ADDRESSES: 705, 711, 713, AND 717 PINE ST

Proposal: Construct rear additions, replace windows

Review Requested: Final Approval Owner: 705 717 Pine Street Associates

OVERVIEW:

Figure 5. View from S. 7th Street of the historic rear ell at 705 Pine Street.

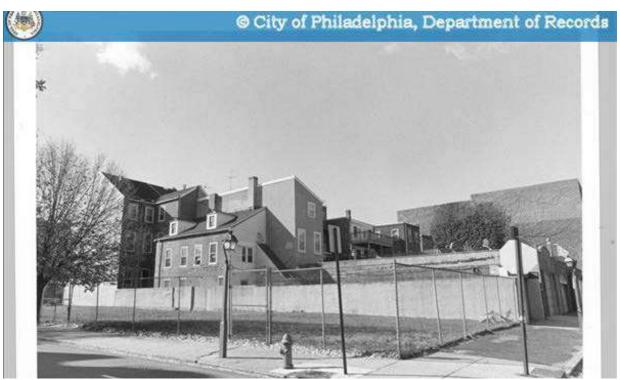
The rear ell of 705 Pine Street is not visible from Delancey Street, which runs along the rears of these properties, but it is visible from S. 7th Street at the side (Figure 5). The scope of work proposed for 705 Pine Street includes removal of the existing rear ell roof and the construction of a one-story addition on the ell and a three-story addition at the rear of the ell, with vinyl or fiberglass windows. Work to the main block includes wood window replacement and roofing.
